Access Compliance Report

Public Rights-of-Way

(Pedestrian Signals)

Intersection ID: N/A	Main Street:	Cross Street: N/A	Location: N/A
ADA ID: 04A9DACD7B54	Signal Type: One Push Button-APS	Overall Compliance: No	Severity Score: BTN 1: N/A BTN 2: N/A No BTN: N/A
Codes/Mitigation Info/Possible Solution		Field Measurements/Component Compliance

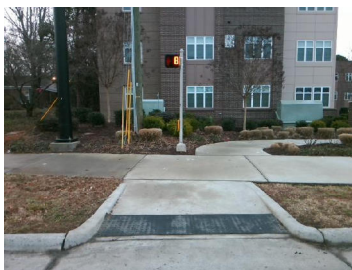
PROW/ADA: TMUTCD 4e.08, R404.2, R404.7.3, R404.7.2, R209.1, MUTCD 4e.10

N/A	B 1 Clear Xing Direction?	Yes	N/A	B 2 Clear Xing Direction?	N/A
	B 1 Crossing Direction	To NW		B 2 Crossing Direction	N/A
Yes	B 1 DistanceTo XWalk (in)	0.0	N/A	B 2 DistanceTo XWalk (in)	N/A
No	B 1 DistanceTo Curb (in)	237.0	N/A	B 2 DistanceTo Curb (in)	N/A
Yes	B 1 Diameter (in)	2.0	N/A	B 2 Diameter (in)	N/A

Possible Solutions: Replace Signal Push Button With APS Button on New Post. Remove & Relocate Sign.
